Westinghouse
Electric Corporation

SUBJECT: RESPONSES TO REQUESTS FOR ADDITIONAL INFORMATION ON THE
NOTRUPM FINAL VALIDATION REPORT

Question 440.599

Figure 440.644-2

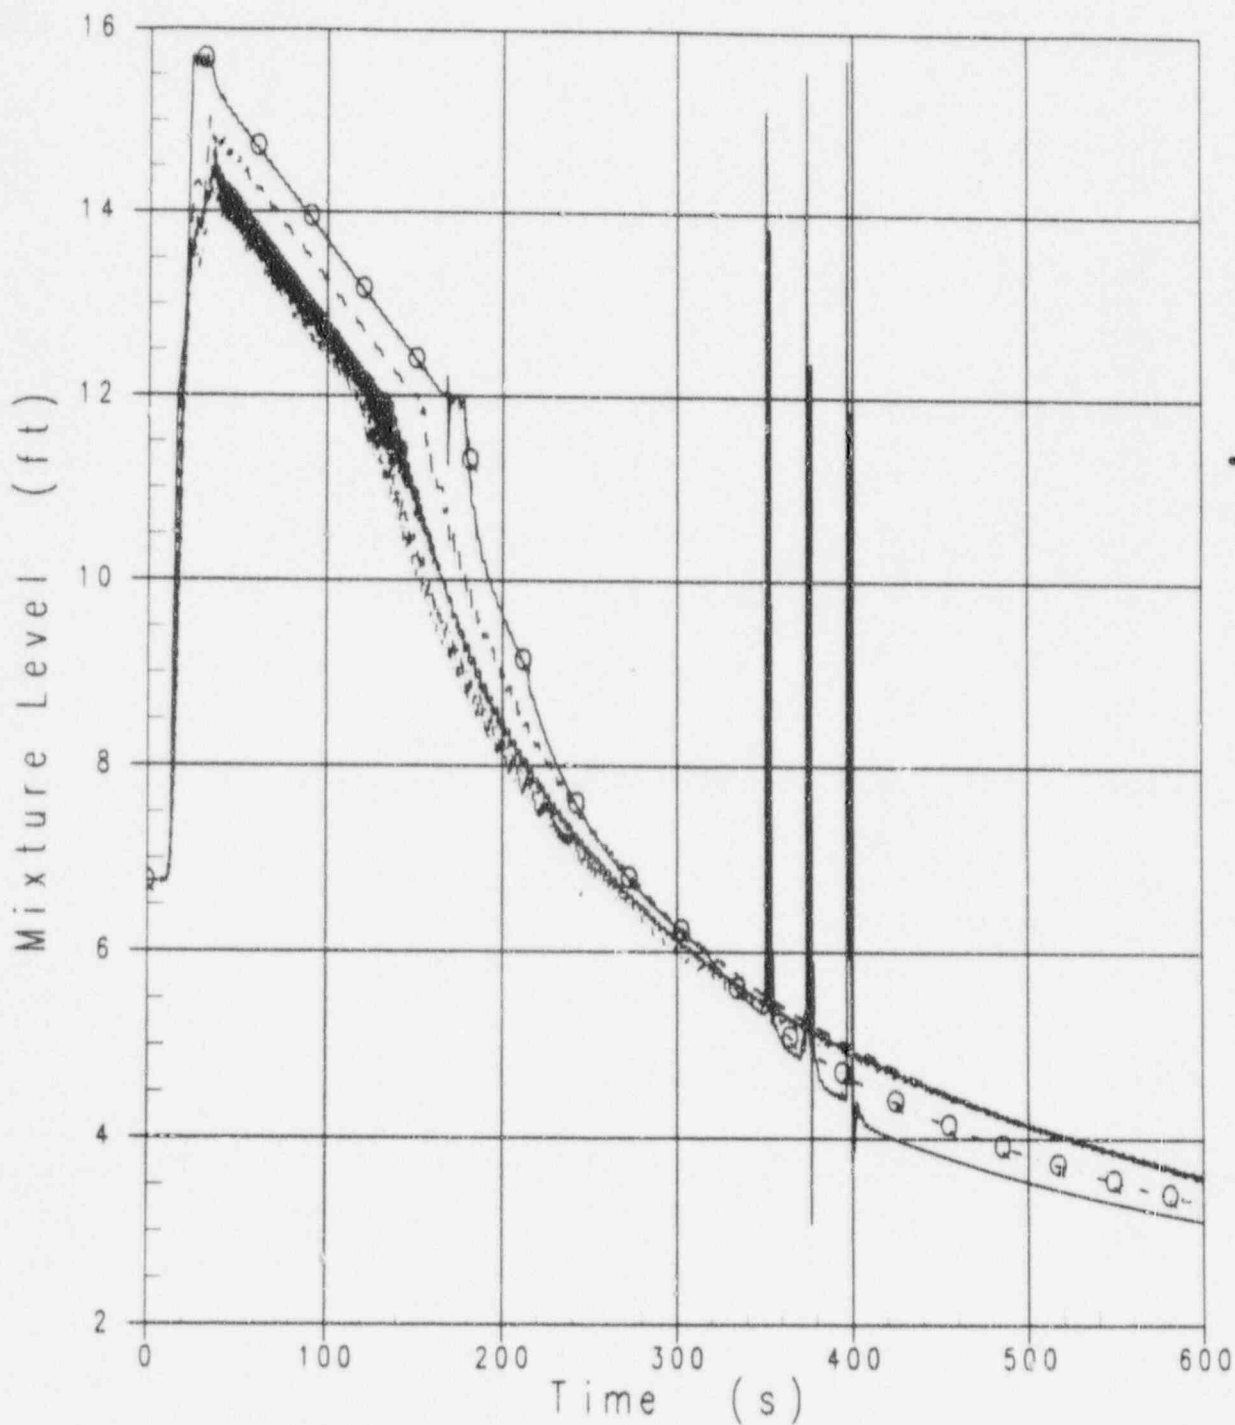
- B. For the Achilles model nodding sensitivity study, the mixture level plot (Figure 4.3-13 of Reference 440.644-2) will be revised to include the results of the four-node model with and without the quench model. The mixture level plot is shown in Figure 440.644-2. The text on page 4.3-6 (last paragraph) of Reference 440.644-2 will also be revised to indicate the use of the core quench model for the four-node Achilles model.
